Lake Calumet Cluster Site  
Briefing with Management, OU2 RI  
February 26, 2020

**RPM Question:** **Are further geologic investigations and/or GW sampling needed to complete OU2 RI?**

Figure 3 – Cross Section A-A''

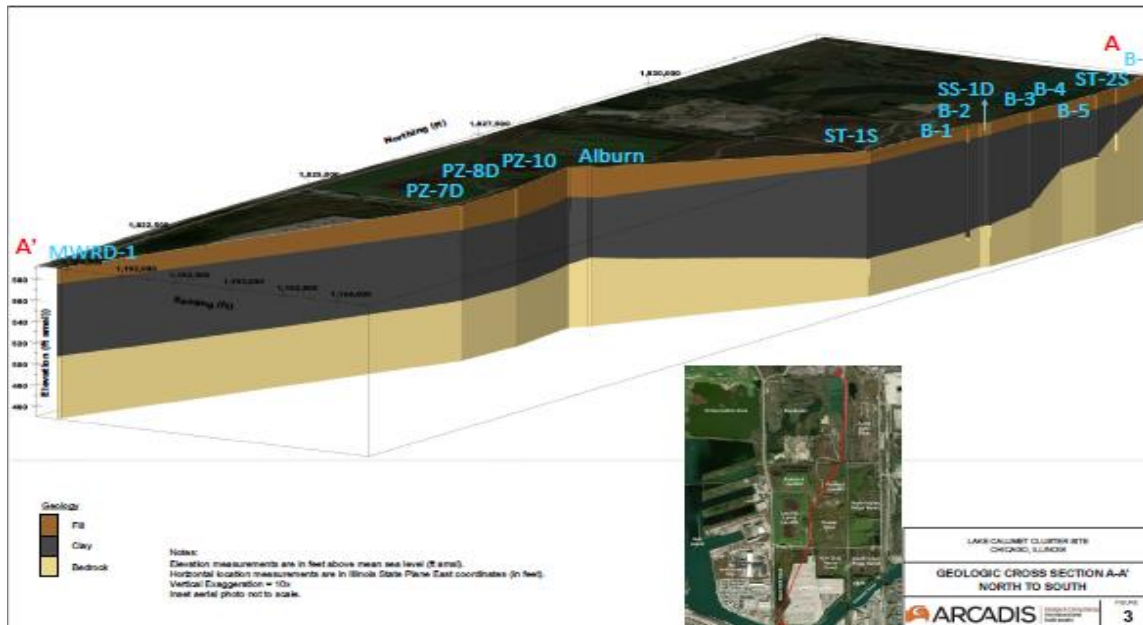
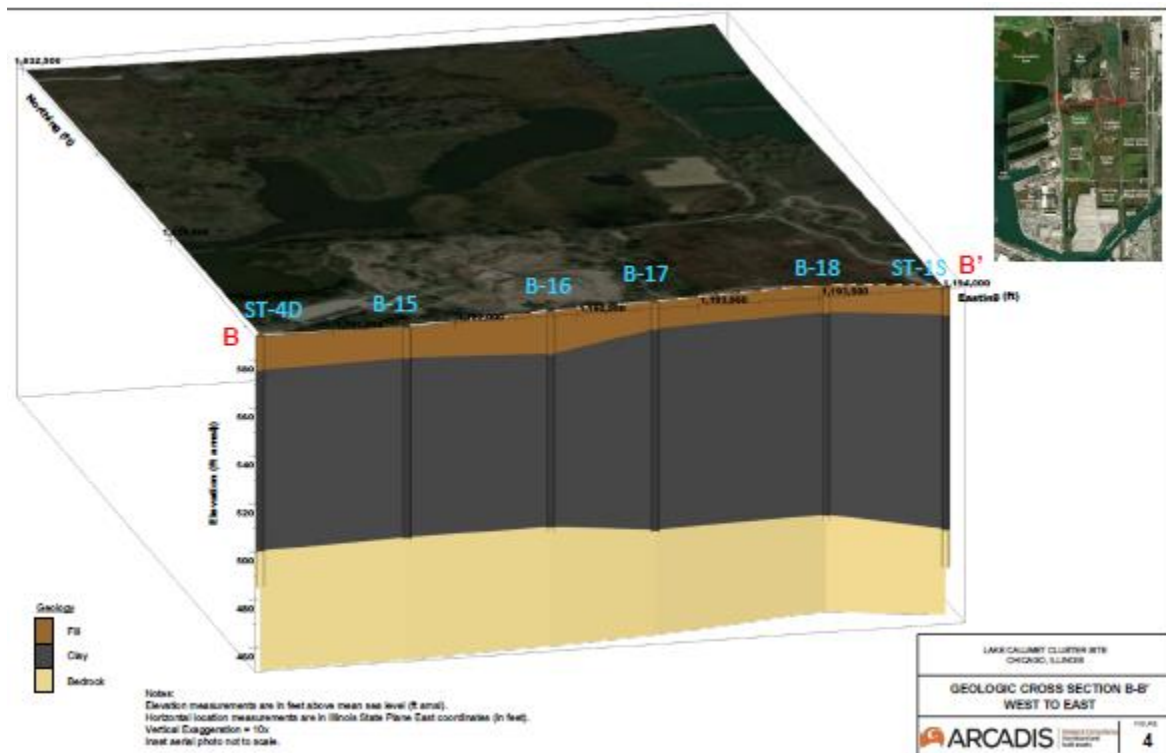
- A decrease in flow and increase in pressure observed at contact between fill and the clay CU
    - **Total thickness of CU not verified during RI. HPT borings terminated in CU and did not penetrate full thickness of unit.**
